Subject: SAS-2: Making 07-193 into an Annex

This is the re-creation of 07-193r1 putting it into a form that can be placed into the SAS-2 standard as an informative annex.

Figure A.1 — S-parameter model of the reference transmitter test load

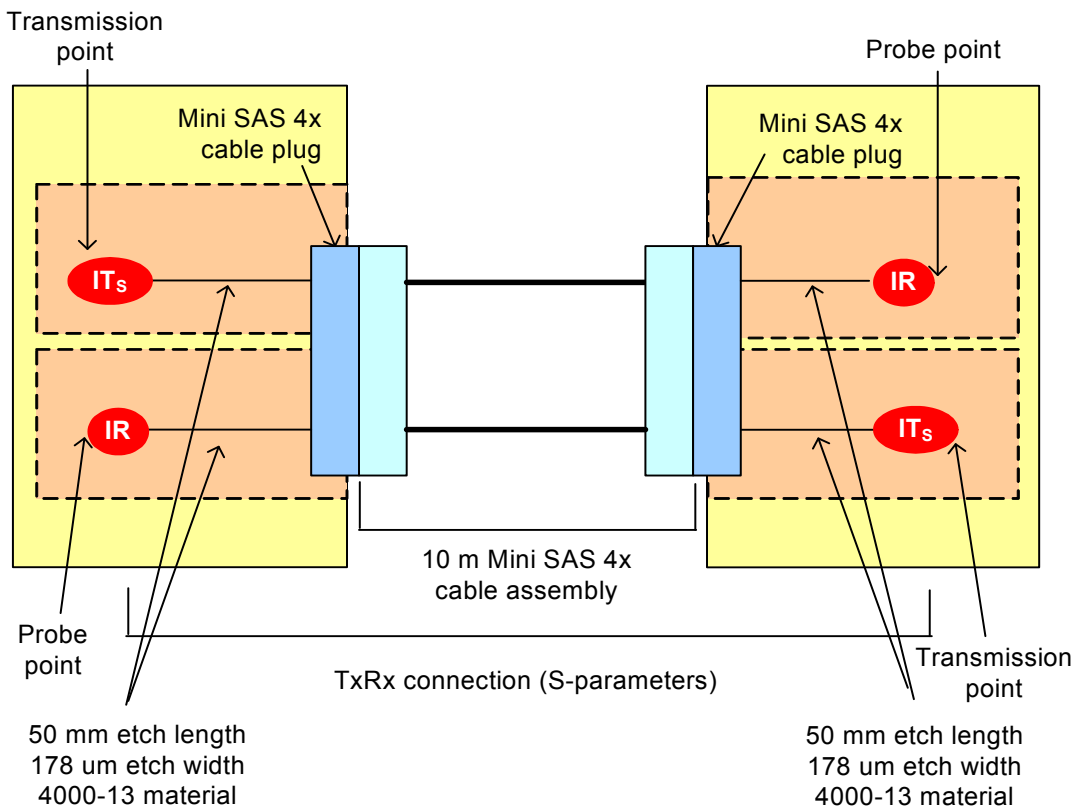
- a) an etch length of 50 mm with an etch width of 178 μm between the IT_s (see 5.3.6.5.4) and the Mini SAS 4x cable plug (see figure A.1) in 4000-13 material environment;
- b) 10 m Mini SAS 4x cable assembly; and
- c) an etch length of 50 mm with an etch width of 178 μm between the IR (see 5.3.7.4.3) and the Mini SAS 4x cable plug (see figure A.1) in 4000-13 material environment.

Figure A.2 — S-parameter model of the reference transmitter test load setup

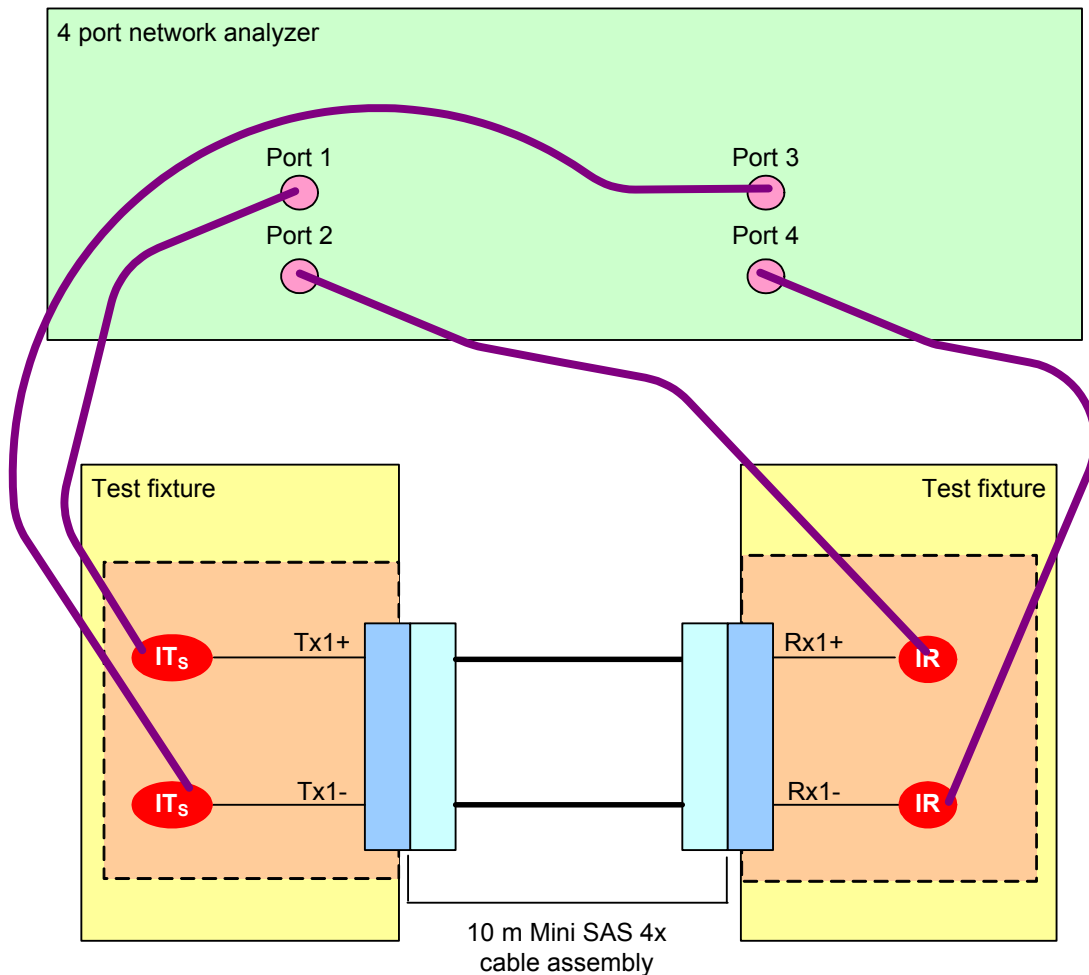
The equipment is interconnected as shown in figure A.2.

Figure A.3 — Reference transmitter test load waveform

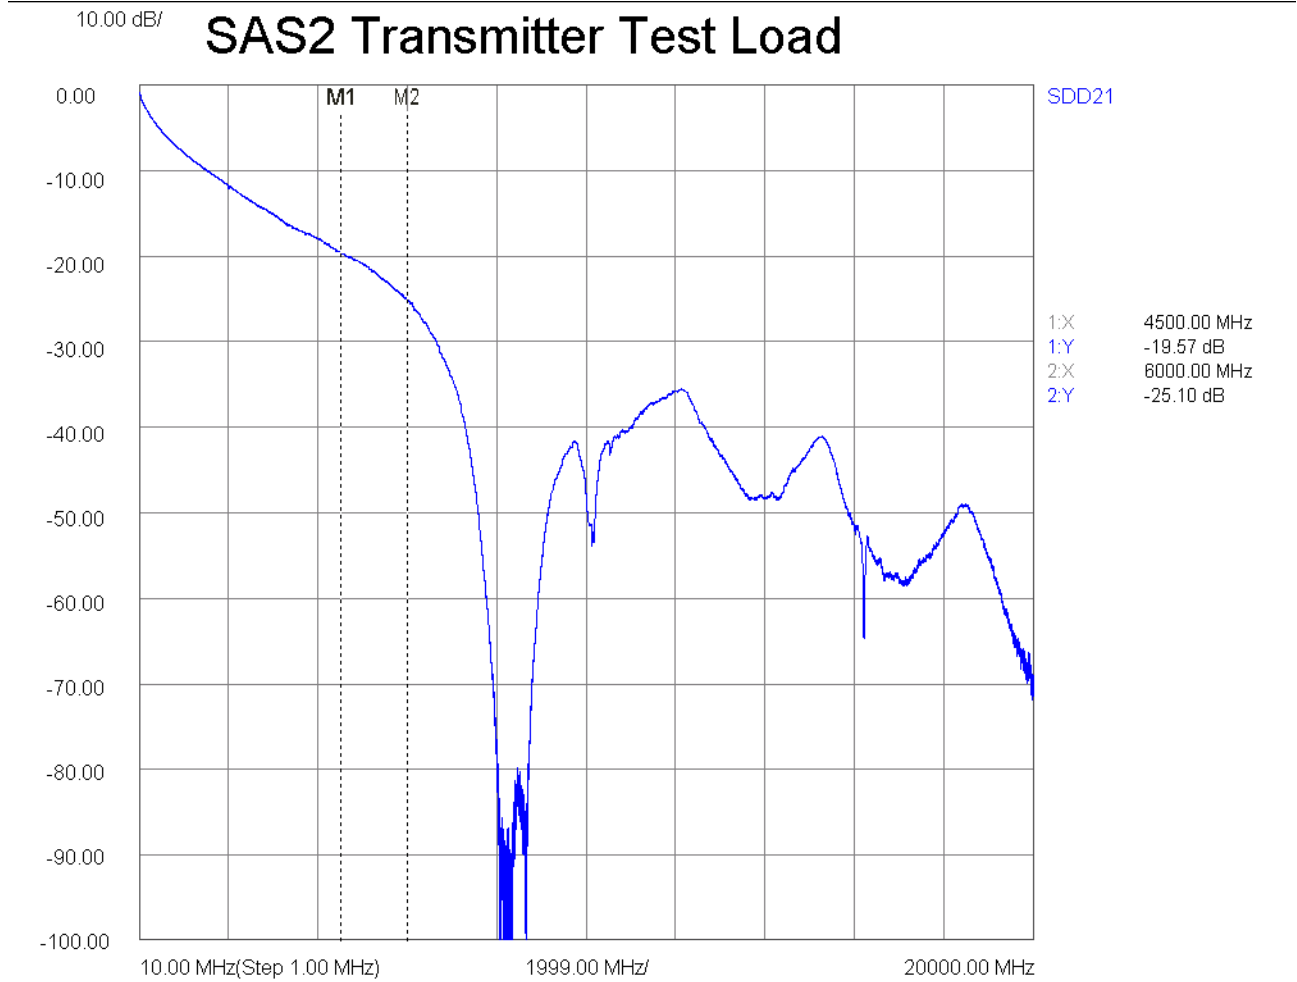
To generate the S-parameters for the reference transmitter test load sweep the 4 port network analyzer from 10 MHz to 20 GHz in 1 MHz steps. The resulting differential insertion loss waveform should be similar to that shown in figure A.3.
